1.27mm*1.27mm Dual Row 25x2 Header
Sullins SFH31-NPPB-D25-SP-BK (Female Header) 3USD
Sullins SBH31-NBPB-D25-ST-BK (Male Header) 3USD
Sullins FFMD-25-D Cable for Female Headers 20USD
Sullins FFSD-25-D Cable for Male Headers 20USD
http://www.opendous.org/BioSensorPlatform
Analog Front-End for Biopotential Measurements
Copyright Under the Creative Commons Attribution License
http://creativecommons.org/licenses/by/3.0/
Opendous Inc. (www.opendous.org)
File: ADS1298_2Layer_Test.sch

Sheet: /
Title: ADS1298 Base Board 2-Layer Test
Size: A4
Date: 17 may 2010
Rev: 1.1
KiCad E.D.A.
Id: 1/1

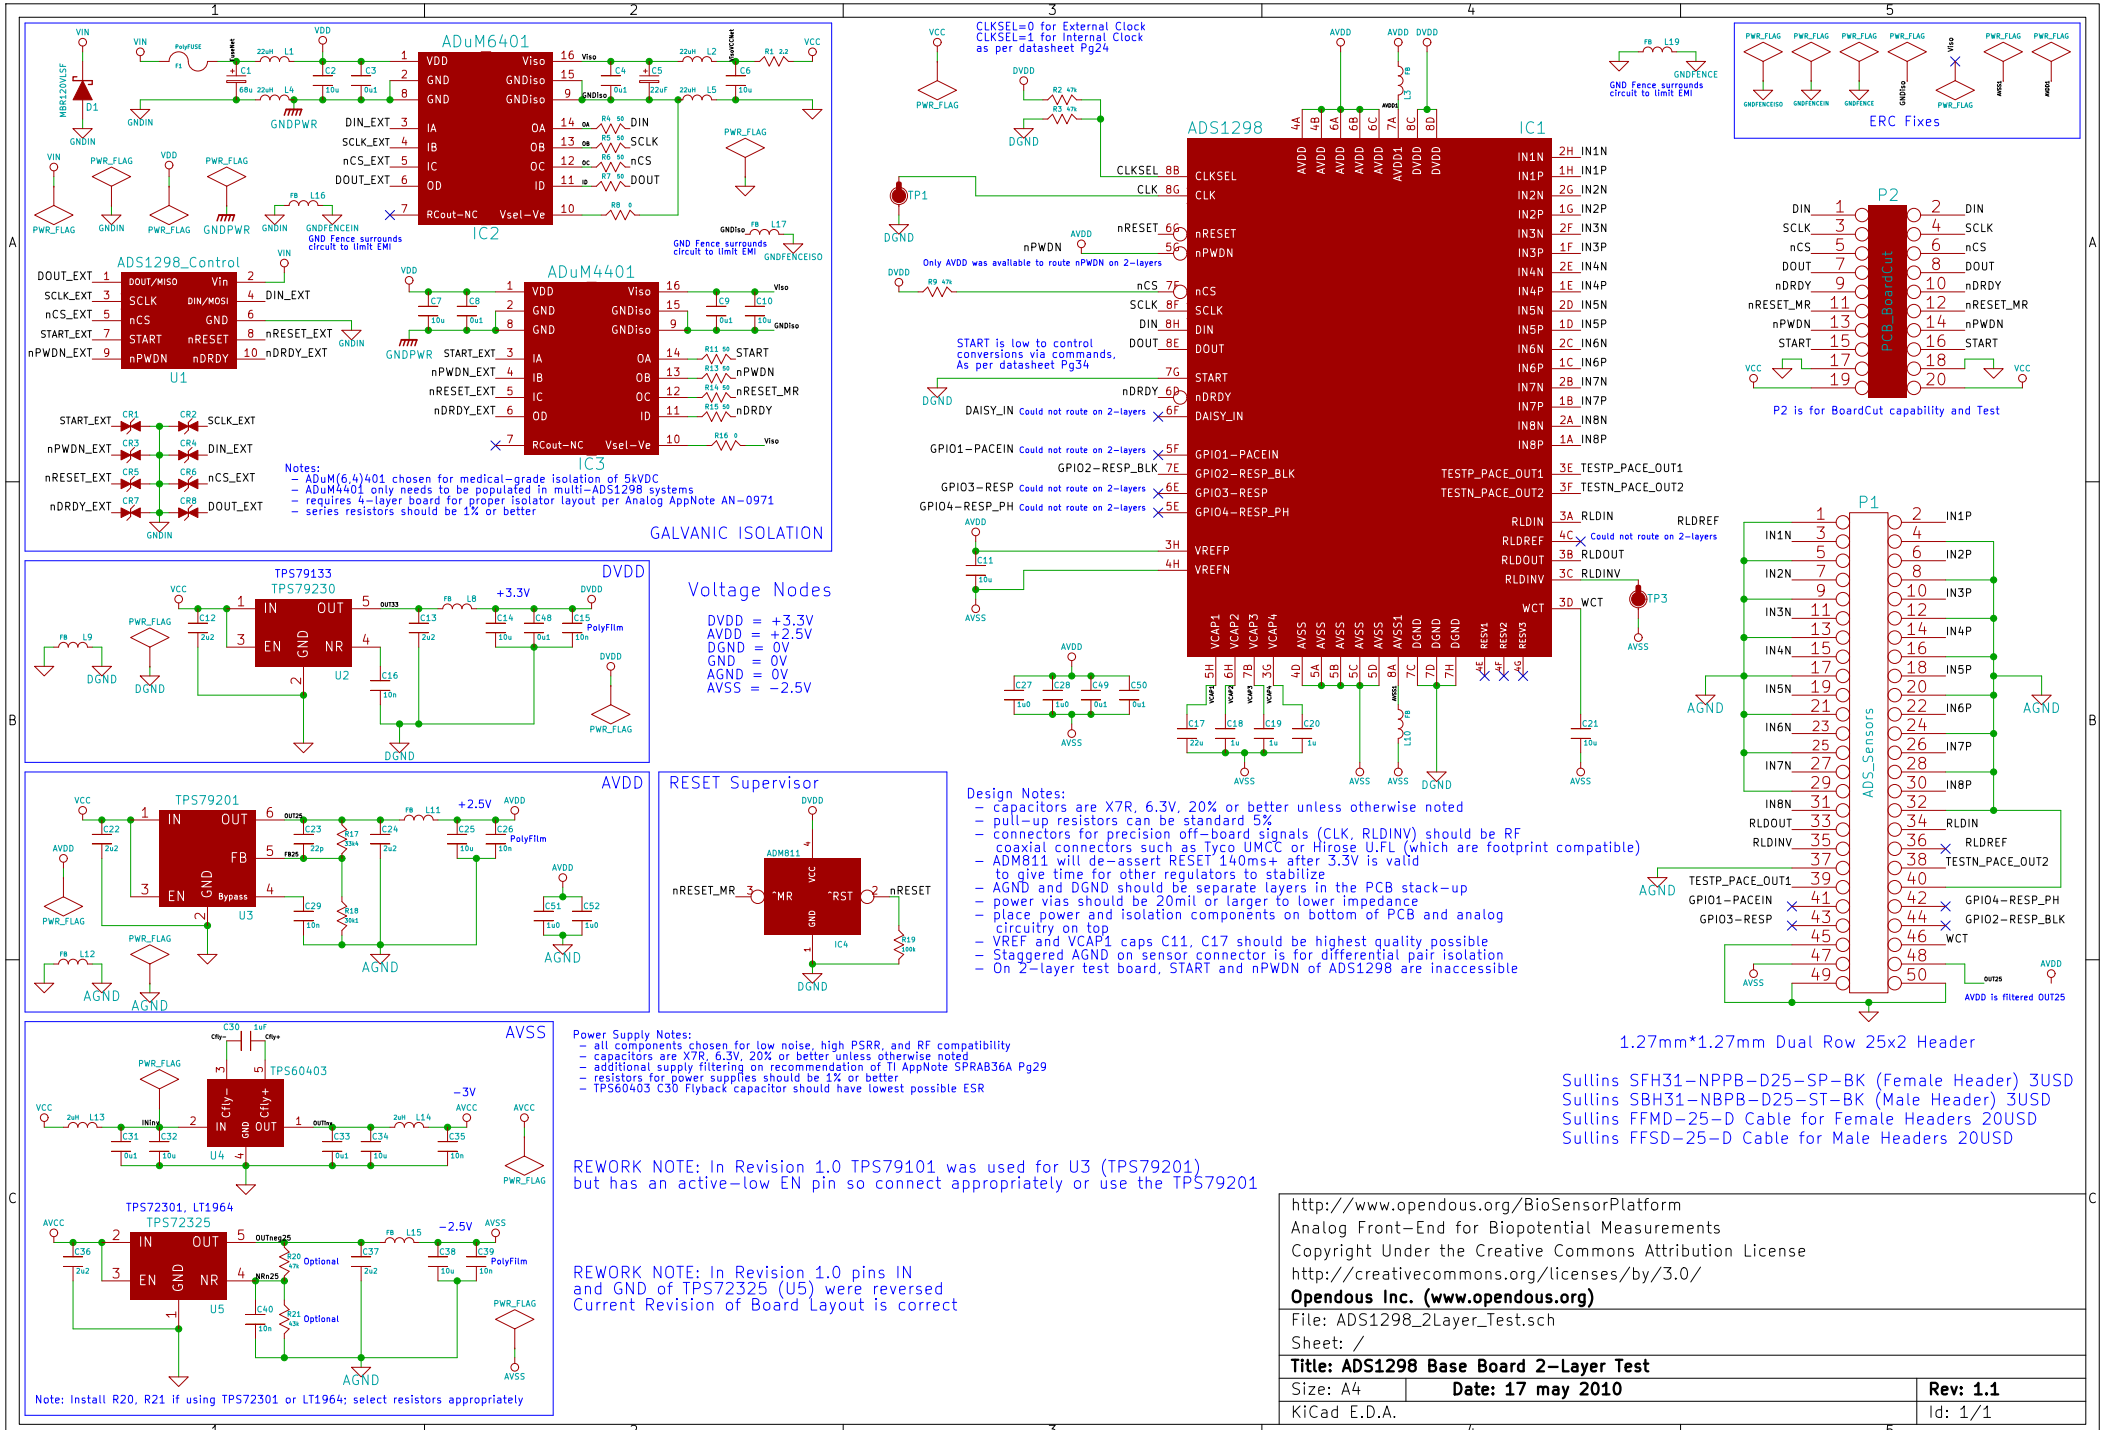
REWORK NOTE: In Revision 1.0 TPS79101 was used for U3 (TPS79201)
but has an active-low EN pin so connect appropriately or use the TPS79201
REWORK NOTE: In Revision 1.0 pins IN
and GND of TPS72325 (U5) were reversed
Current Revision of Board Layout is correct
CLKSEL=0 for External Clock
CLKSEL=1 for Internal Clock
as per datasheet Pg24
ADS1298
IC1
Only AVDD was available to route nPWDN on 2-layers
START is low to control
conversions via commands,
As per datasheet Pg34
DAISY_IN Could not route on 2-layers
GPIO1-PACEIN Could not route on 2-layers
GPIO2-RESP_BLK
GPIO3-RESP Could not route on 2-layers
GPIO4-RESP_PH Could not route on 2-layers
Could not route on 2-layers
GND Fence surrounds
circuit to limit EMI
ERC Fixes
P2
PCB_BoardCut
P2 is for BoardCut capability and Test
P1
ADS_Sensors
AVDD is filtered OUT25
Design Notes:
– capacitors are X7R, 6.3V, 20% or better unless otherwise noted
– pull-up resistors can be standard 5%
